City of Oregon City

Meeting Agenda - Final-revised

Planning Commission

3a. NR 18-08 and US 18-02: Natural Resource Overlay District and Geologic Hazard Review for existing patio and realted improvements at 1st Avenue between Jerome and Miller Streets in Canemah

Sheet 7 of 7

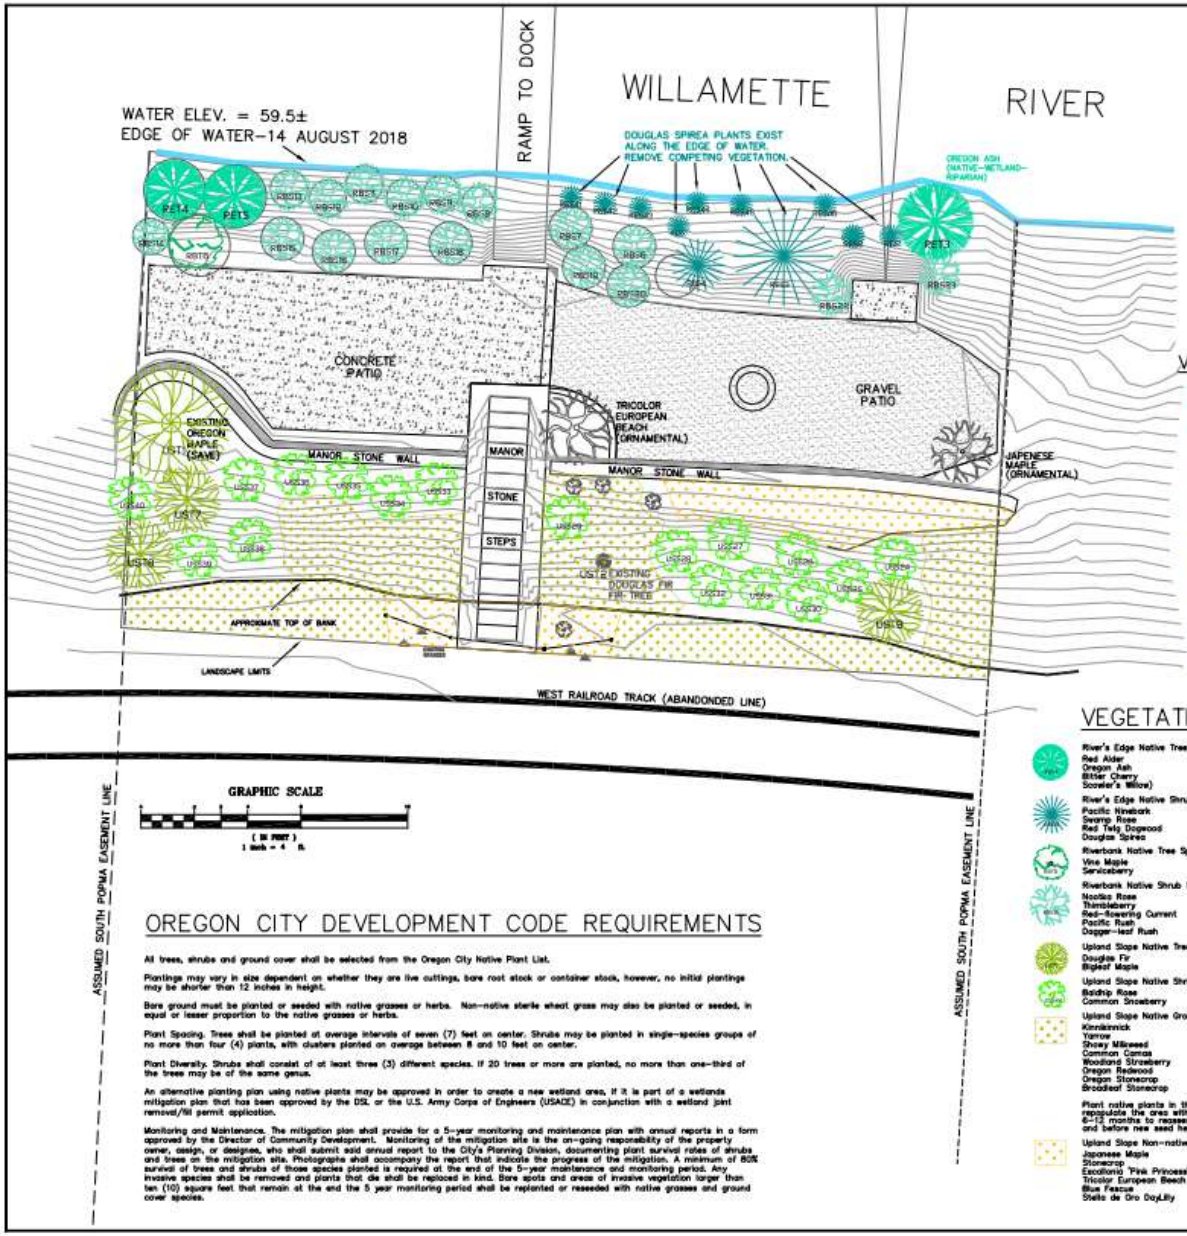
4. The applicant's planting plan must be revised to include 8 trees and 42 shrubs; existing plants may not be counted. Additional plants may be planted on the applicant's site or offsite as required by other conditions of approval. (P)

5. The final mitigation plan shall include at least three different shrub species. (P)

6. The applicant shall revise the species in the planting plan to: (P)
   - Remove serviceberry from the list of tree options; serviceberry is a shrub and may not be counted as a tree.
   - Re-label oxalis oregana as "Redwood sorrel" if it is retained in the final mitigation plan.
   - Remove rush from the list of shrub options; rush is a ground cover.

7. The applicant shall revise the mitigation plan to meet plant spacing requirements; however, spacing may be reduced to accommodate additional plants if necessary. (P)
